ADDENDUM NO. 1

LONGVIEW MULTIMODAL TRANSPORTATION CENTER
CITY OF LONGVIEW, TEXAS

TUESDAY, SEPTEMBER 1, 2015.

C5.0

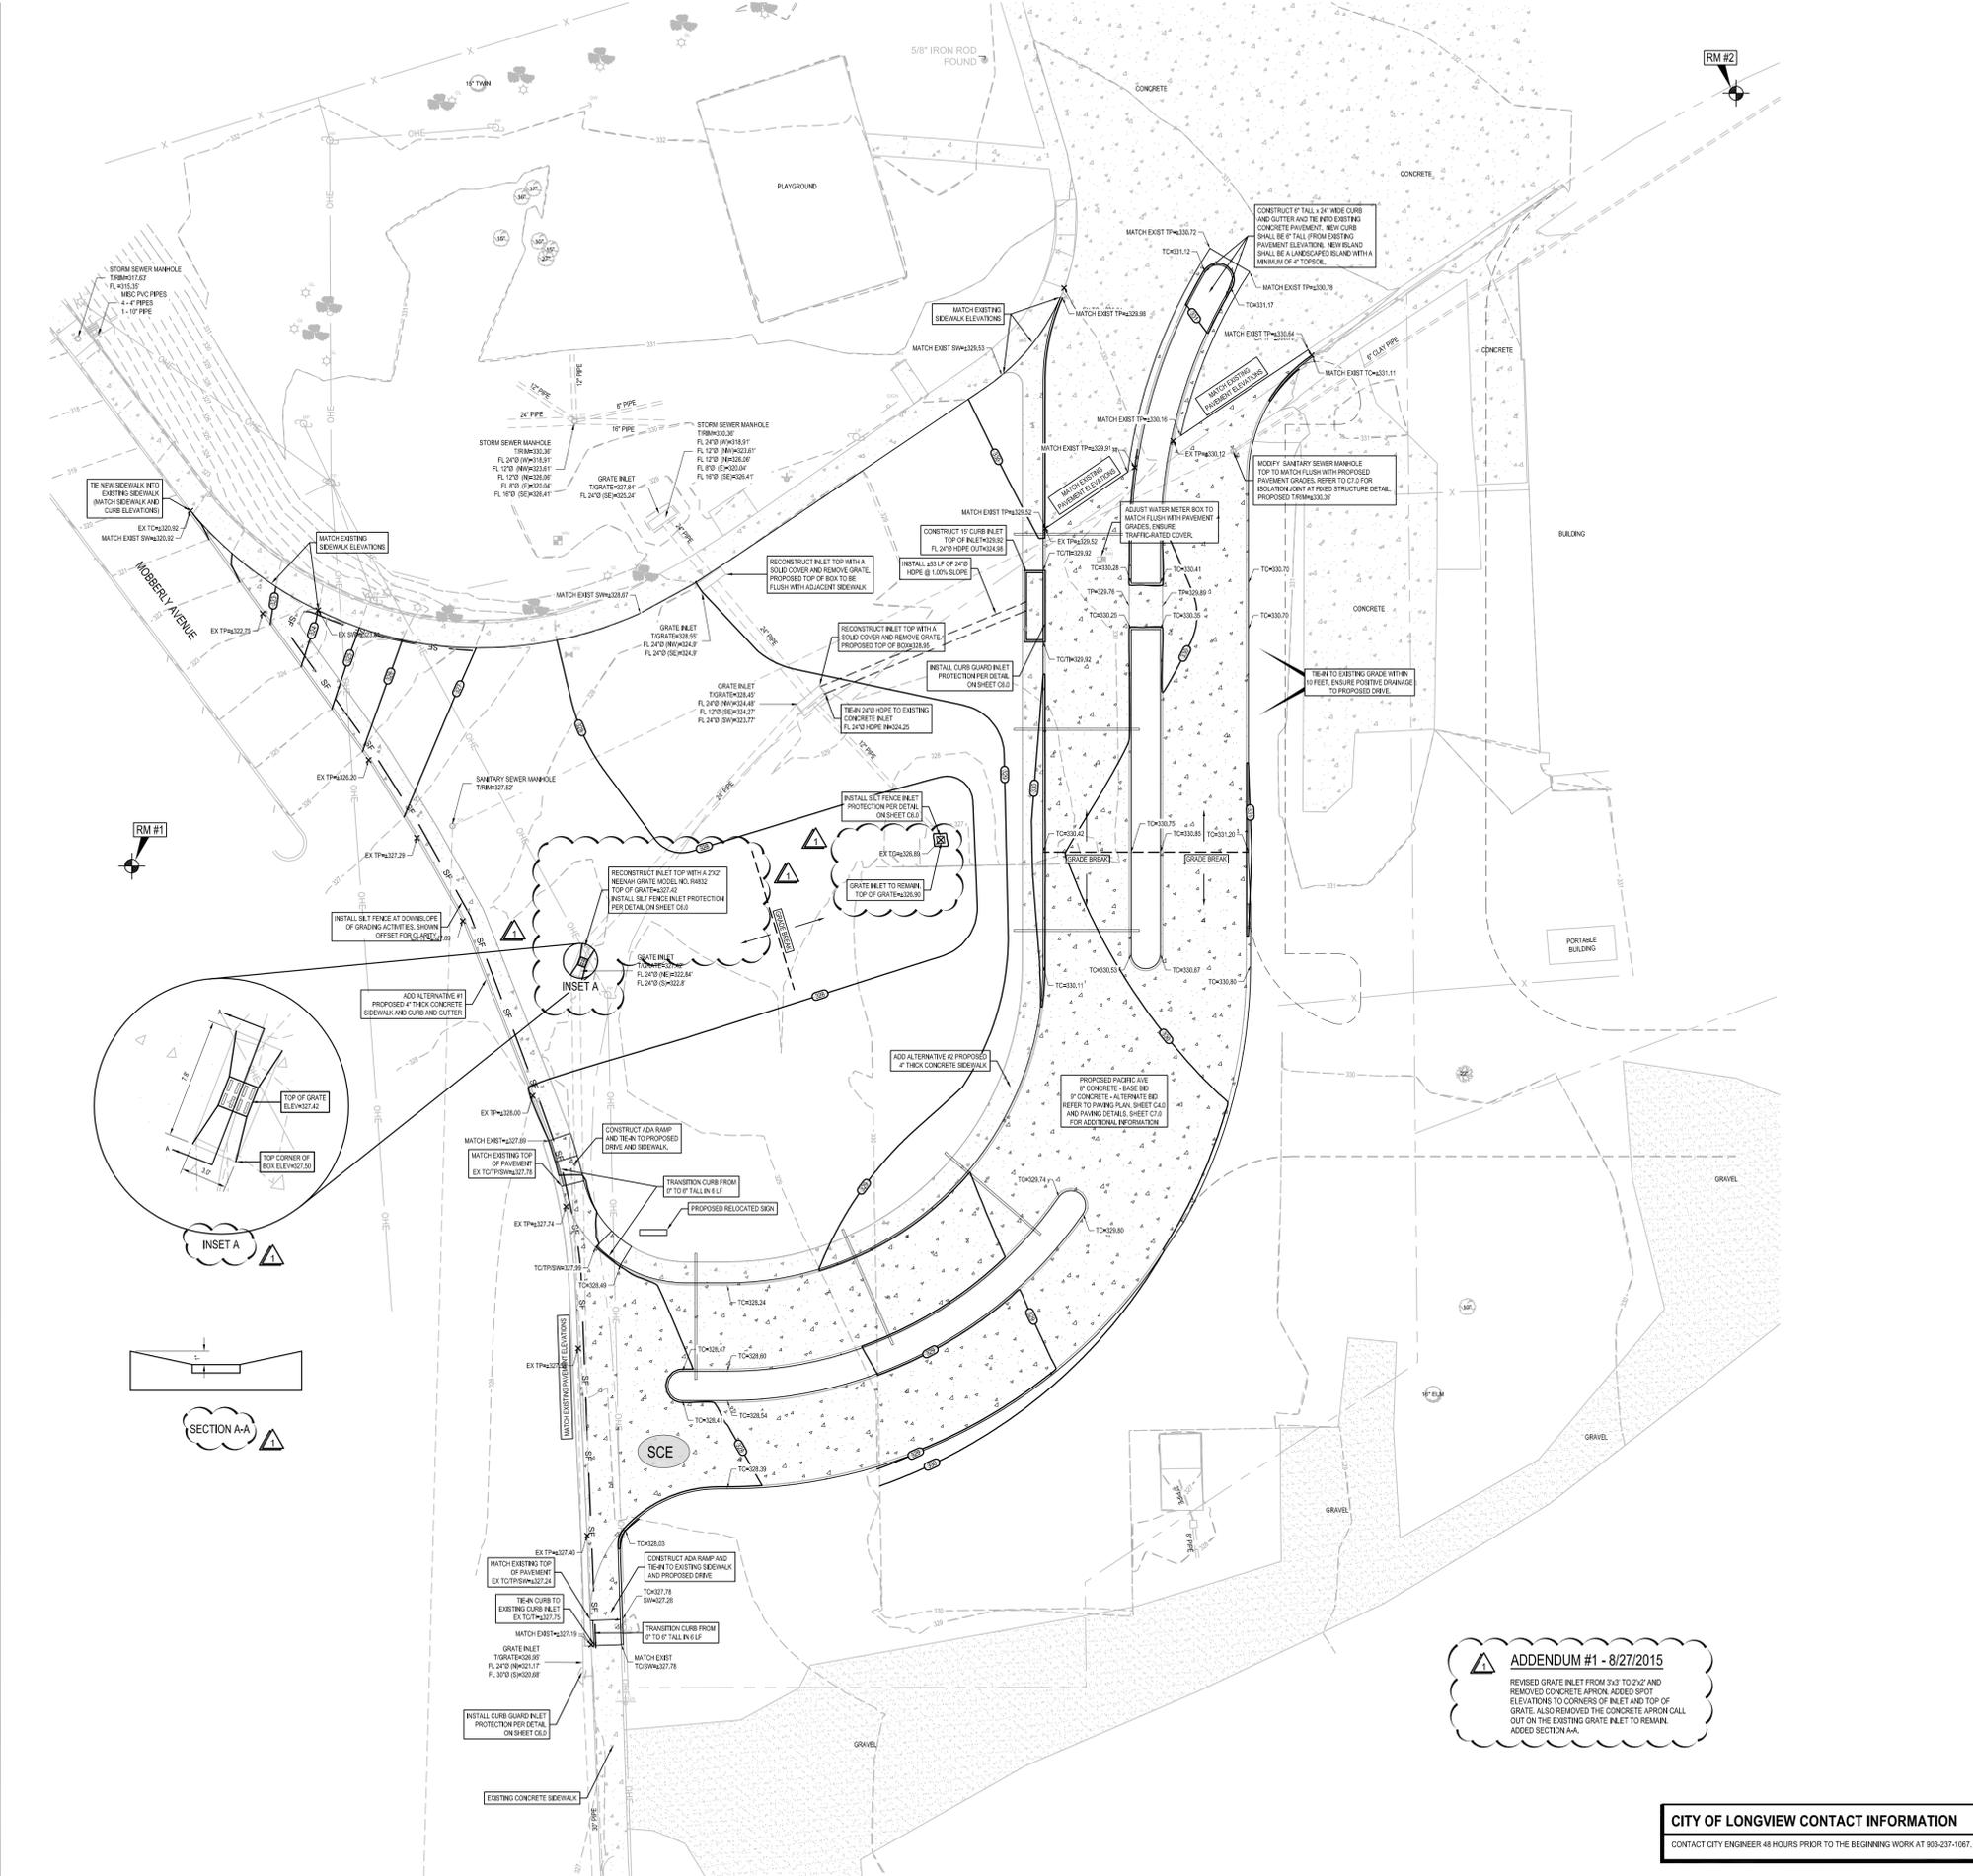
Sheet C5.0 – Grading and Paving Plan: Replace sheet C5.0, dated 8-17-15, with the Revised Sheet C5.0 dated 8-27-15.

1. The call out for a 3'x3' Grate Inlet Top has been changed to call out for a 2'x2' Grate Inlet Top and the concrete apron has been removed. Specific grades are shown to corners of the concrete top and the grate.
2. An enlarged detail of above said grate/inlet has been provided along with Section A-A.
3. The concrete apron has been removed from the existing grate inlet that is to remain.

REVISED GRATE INLET FROM 2'x2' TO 2'x2' AND REMOVED CONCRETE APRON. ADDED SPOT ELEVATIONS TO CORNERS OF INLET AND TOP OF GRATE. ALSO REMOVED THE CONCRETE APRON CALL OUT ON THE EXISTING GRATE INLET TO REMAIN. ADDED SECTION A-A.
